Access Compliance Report

# Public Rights-of-Way
(Curb Ramps)

Intersection ID: 26389	Main Street: BONNIE_BUTLER_WY	Cross Street: TWELVE_OAKS_PL	Location:	NW
ADA ID: 81FEAC7C734D	Ramp Type: BlendTrans1	Initial Pass/Fail: Fail	Overall Compliance: No	Severity Score: 1.25

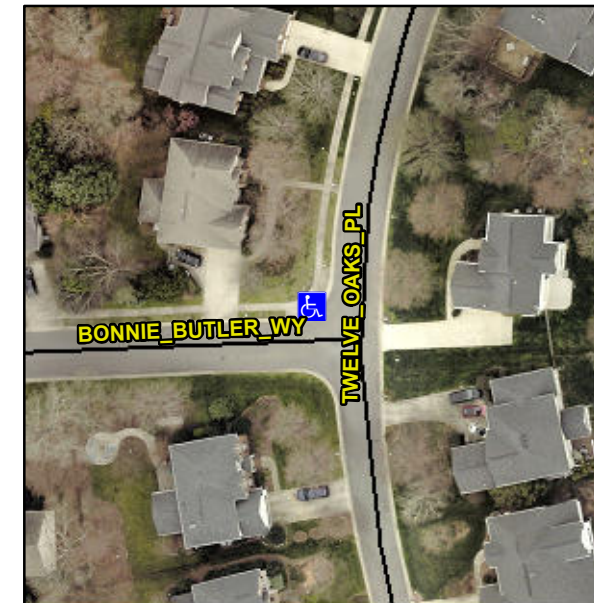
Remove & Replace Curb Ramp With Two New Directional Ramps or Equivalent.

Not Found, R304.5.3
